**TOWN OF KENT
ARCHITECTURAL REVIEW BOARD
KENT VILLAGE DISTRICT**

OCTOBER 25, 2018 SPECIAL MEETING MINUTES

- 3.A.** Application #016-18, MKN Property Holding, LLC, 5 South Main Street, new store front (new windows, new exterior lighting, new hardy board siding) and 14' addition to westerly side of building, Map 19 Lot 12 Lot 5.

From: **John Milnes Baker, AIA** member of the Kent Architectural Review Board
To The members of the Kent ARB
Re. Kent Mobile, 5 South Main Street, Kent CT Application
Subj. Comments

WEST ELEVATION (NOT NORTH - RIB 7 RUNS N/S) ①

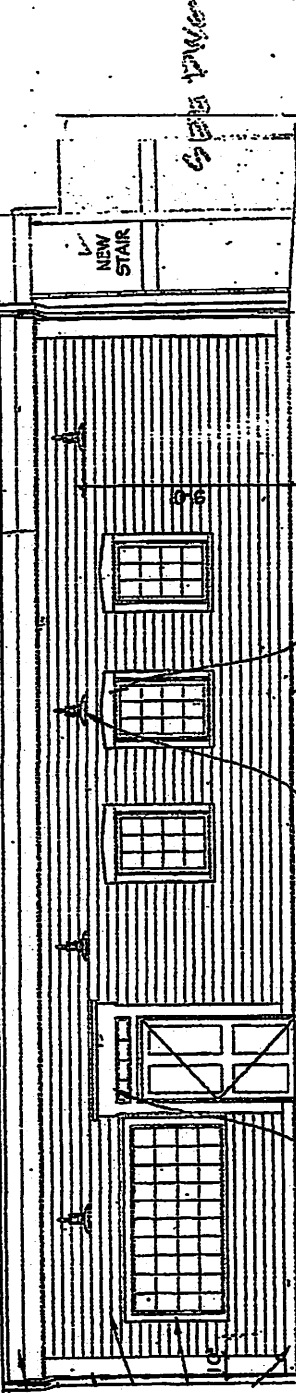
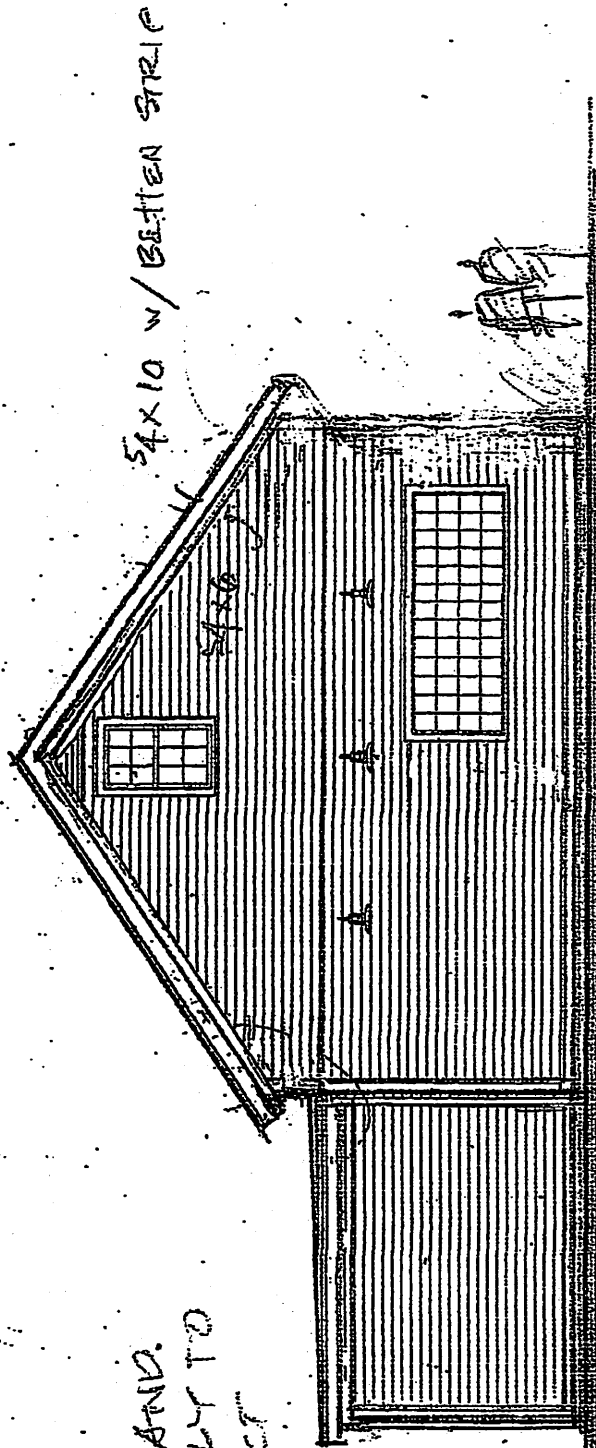
- 1) Route 7 runs generally North/South – not East/West. The long elevation facing Route 7 should be labeled the WEST ELEVATION (It would be confusing to anyone who lives in Kent) See Dwg. 1

- 2) The eave detail is not acceptable. The ARB booklet **REQUIRED DOCUMENTS and HELPFUL SUGGESTIONS** – page 4 of 7 - clearly shows what eave details are acceptable and which ones are not. Though the proposed detail is not specifically shown in the booklet, it should have been. (My mistake.- it will be amended) I have shown on the attached **Drawings 1 and 6** what would be appropriate.

① BE SURE THE CABLE END OVER HANG IS AT LEAST AS LONG AS THE EAVES.

EAVE
DETAIL
NO PORT
CHOPS
EITHER

NORTH ELEVATION SCALE 1/8" = 1'-0" (NOT EAST)

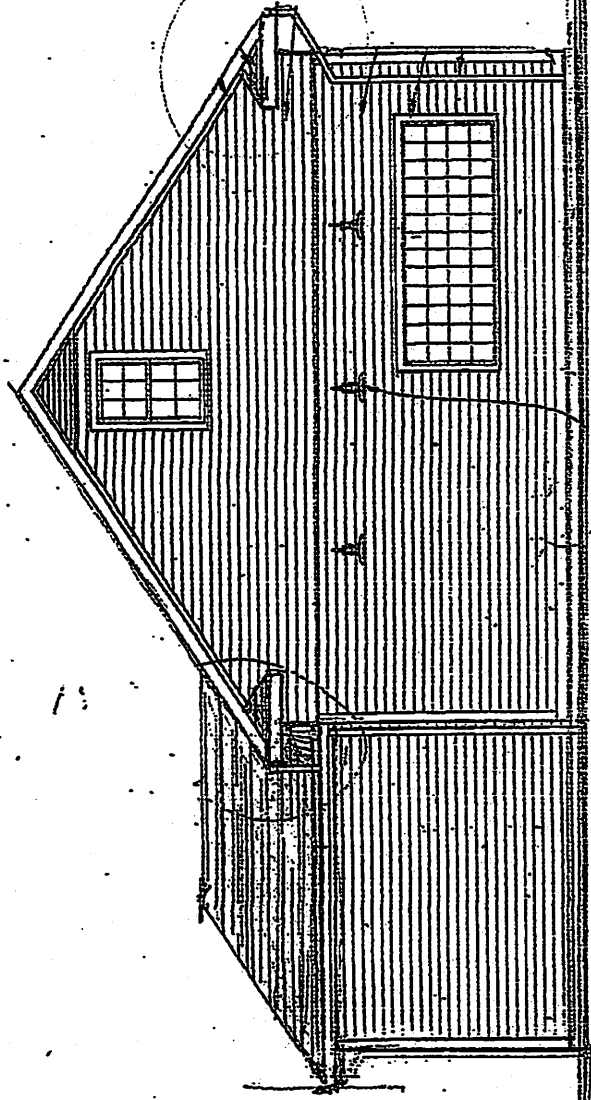
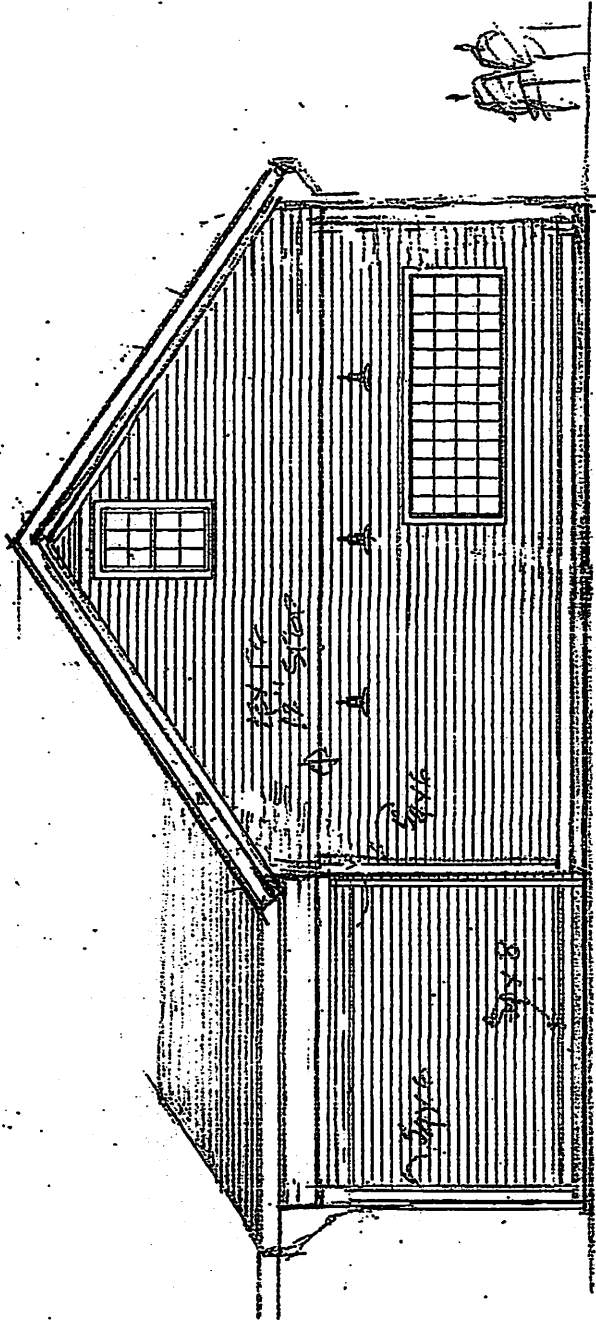
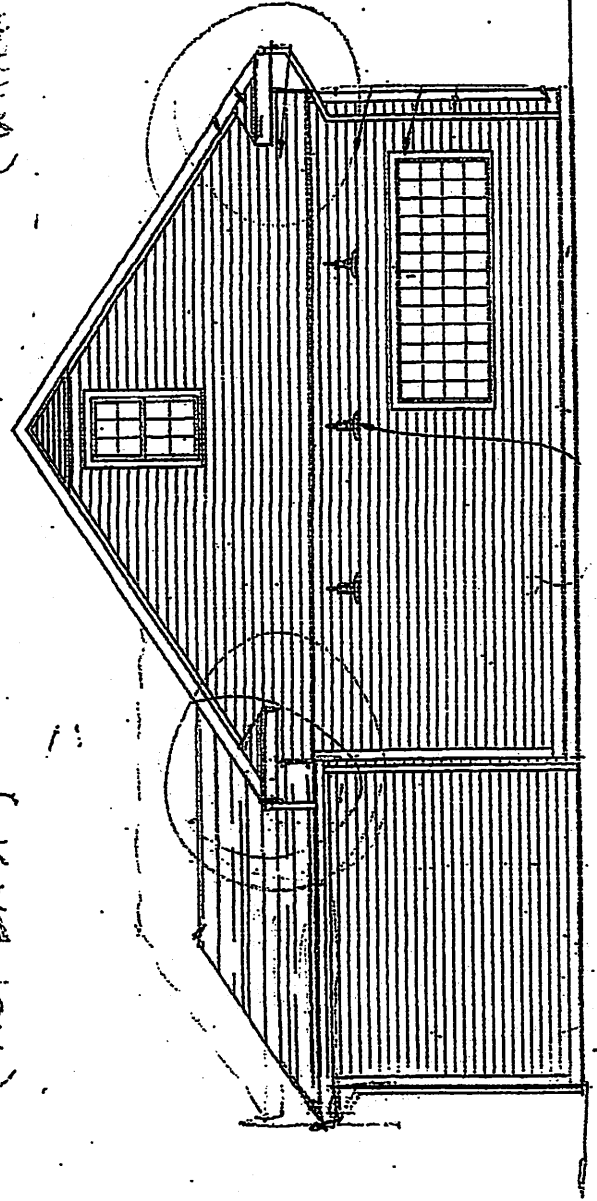
- 3) The merging of the addition with the main structure is very awkward. There were two options proposed. My **Drawings 2, 3 and 4** show both options but modified to be more simpler and cohesive thus making the addition more integrated into the overall design.

PROPOSED - NOT ACC.

NORTH ELEVATION (VIEW FROM RTE 341...)
(NOT EAST)

SIMPLER AND.
LESS COSTLY TO
CONSTRUCT

EAST ELEVATION SCALE: 1" = 1'-0"

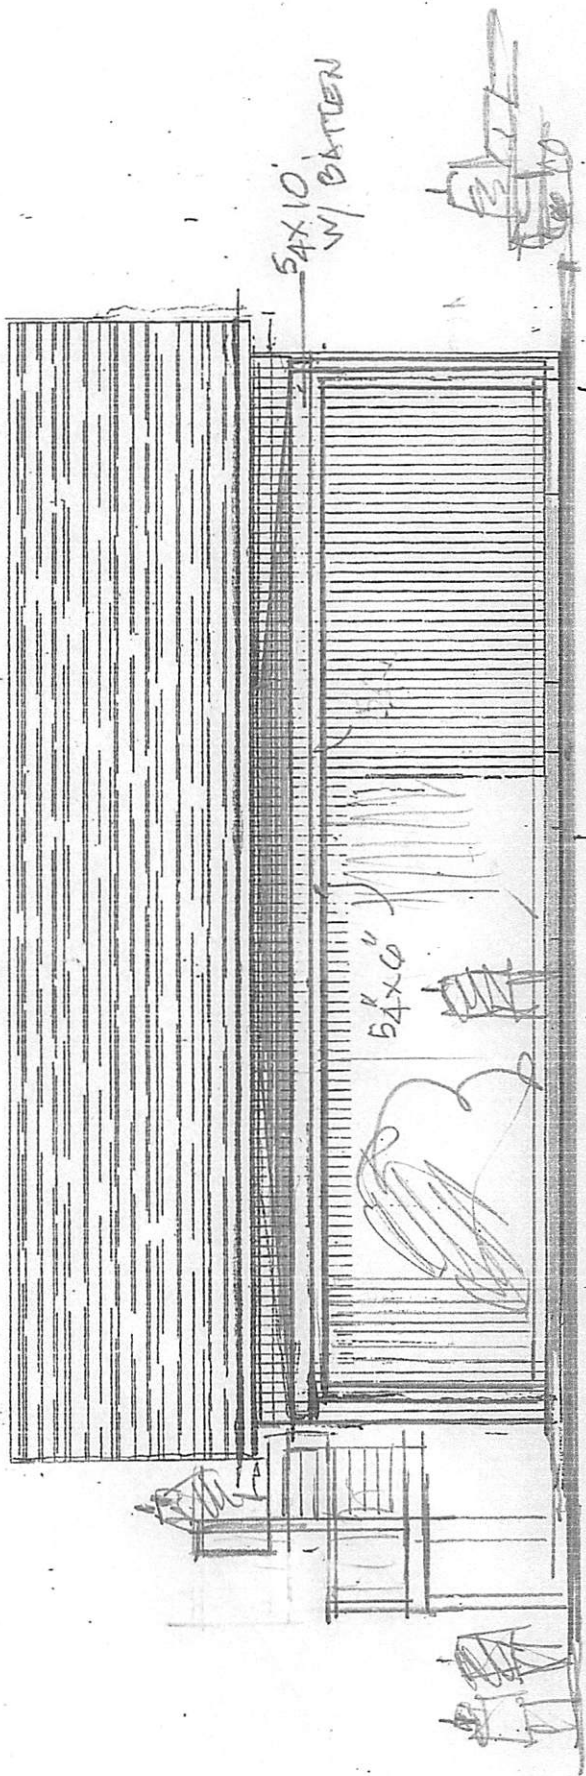
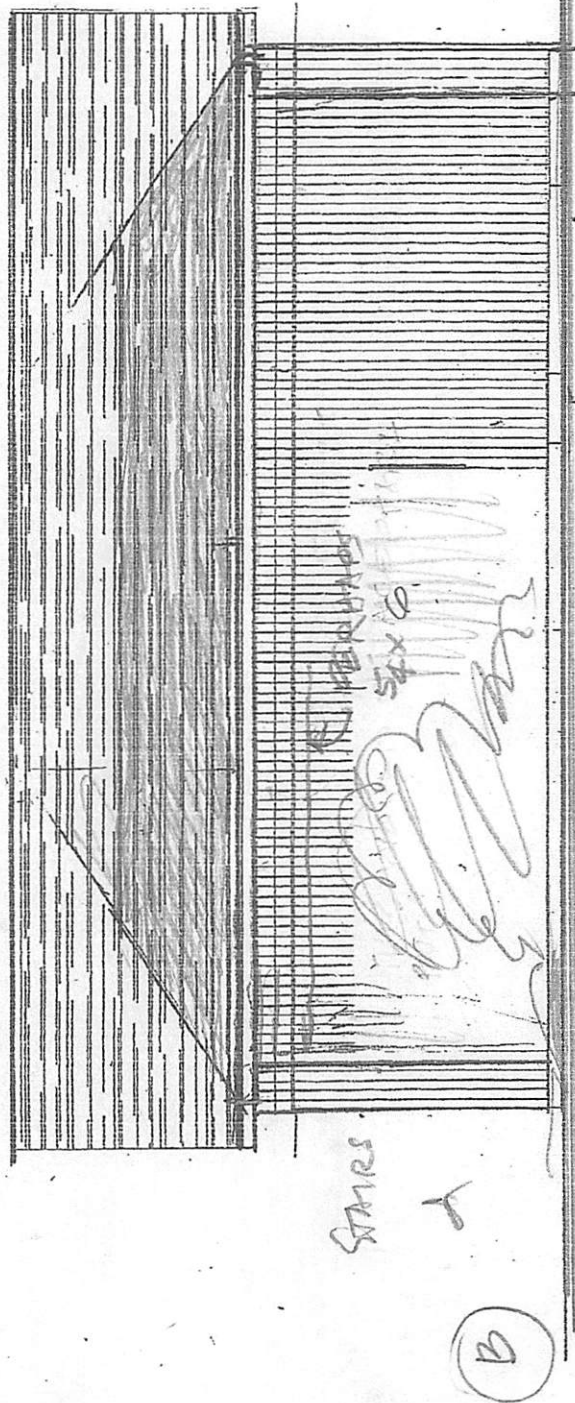
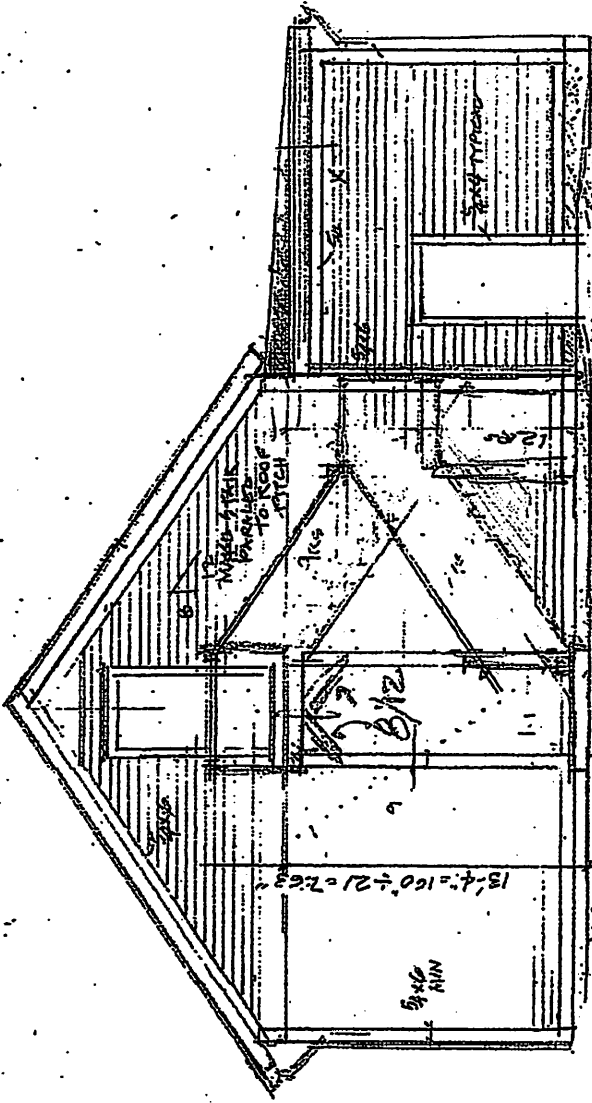
PROPOSED - NOT ACCEPTABLE

5'4" x 10" w/ BATTEN

5'4" x 6"

SOUTH ELEVATION (NOT WEST)
(RTE 1 RUNS N/S)

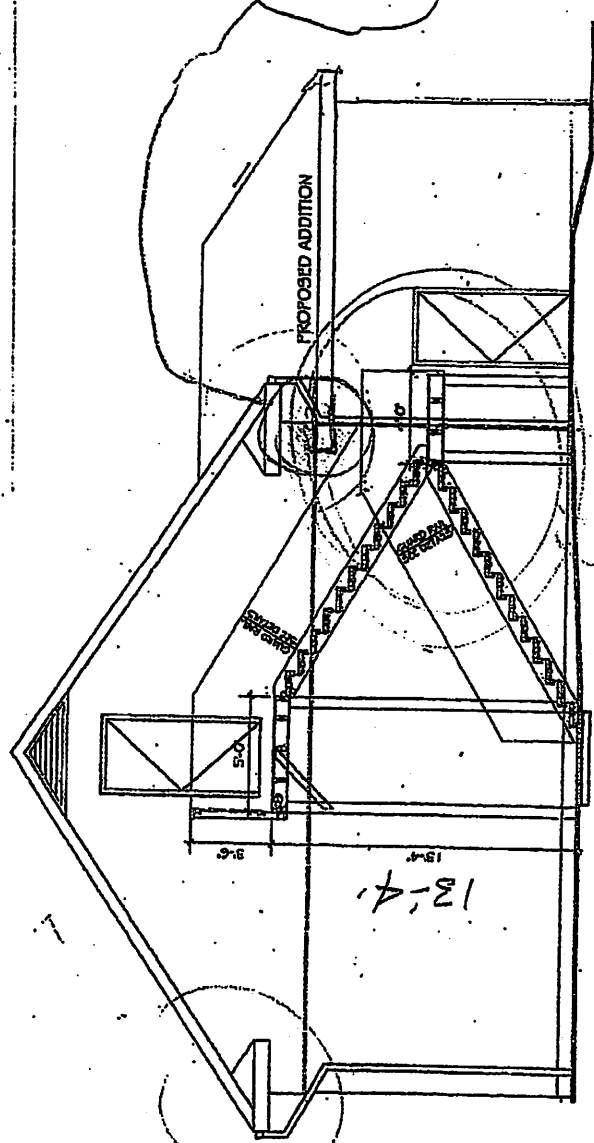
- 4) The exterior stairway on the SOUTH end of the building is very awkward as well. It looks stuck on and not compatible with the massing of the whole building. There is no reason why the intermediate landing platform has to stick out past the corner of the building. The drawings show 25 risers – there only has to be 21. (Note that the overall rise is 13'-4" or 160 inches. $160 \div 21 = 7.62''$ per riser. If the tread is adjusted to approximately 11.43 the slope will be parallel to the 8 to 12 roof pitch. Though this may not seem to be critical, the SOUTH side is very visible from Route 7 and will make the appearance much more integrated. See **Dwgs 5 and 6**

THIS IS A MESS!

NO NEED TO HAVE PLATFORM
EXTEND PAST THE SE CORNER. DON'T NEED 25 RISERS

WOULD HAVE TO
SHOW OVERHANG OF
THIS ADDITION IF
ONLY 5' SET BACK
